SERVICE BULLETIN

No. AS-1112
DATE 1/16/90
FILE IN Position

SUBJECT Honda Ignition Change – Effecting Key Blanks

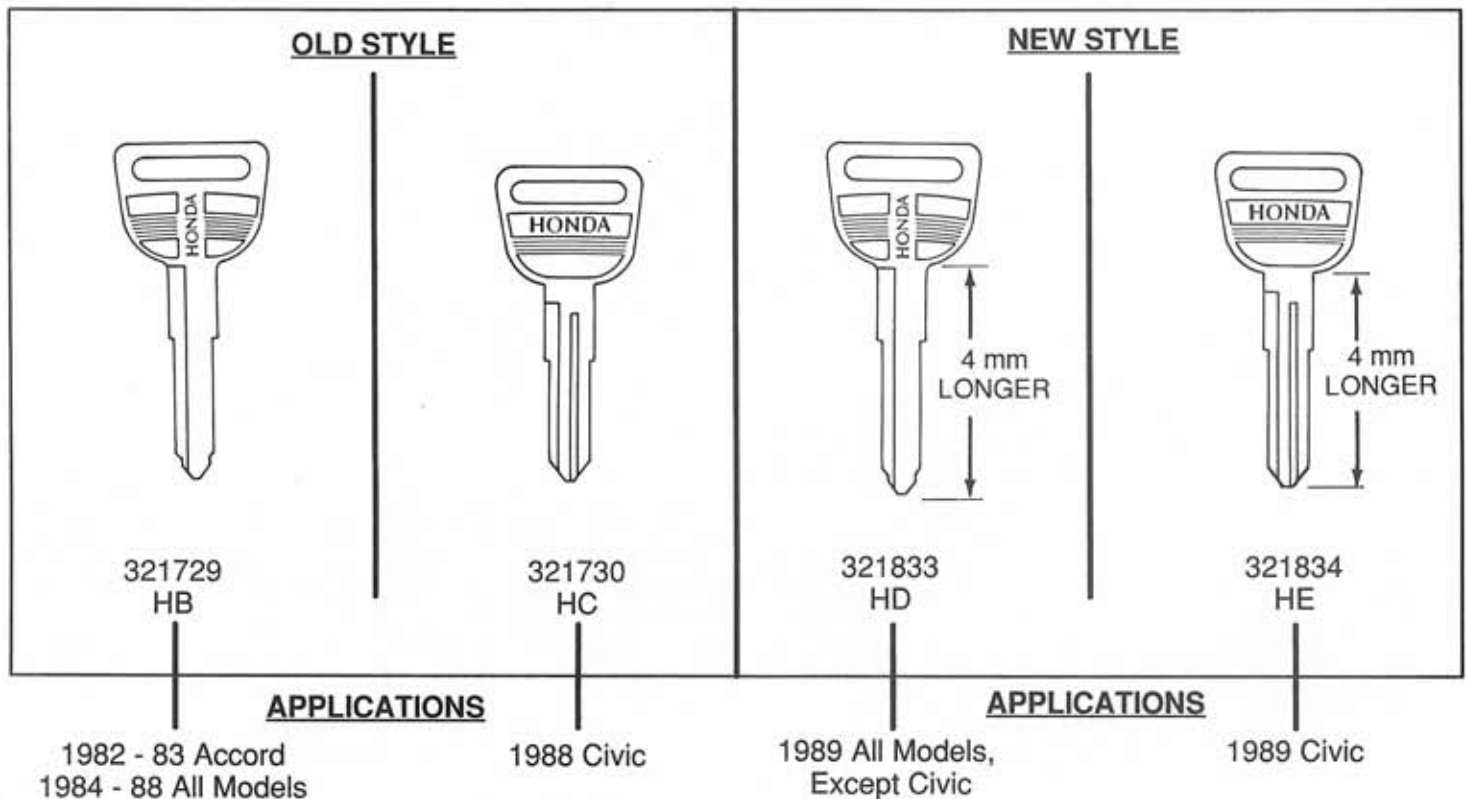
HONDA Corp. has incorporated a "Push To Lock" feature on their 1989 vehicles. This will require the key blank to be 4mm longer to function.

Do NOT use the 1988 key blank in a 1989 VEHICLE.

The key will become lodged in the ignition.
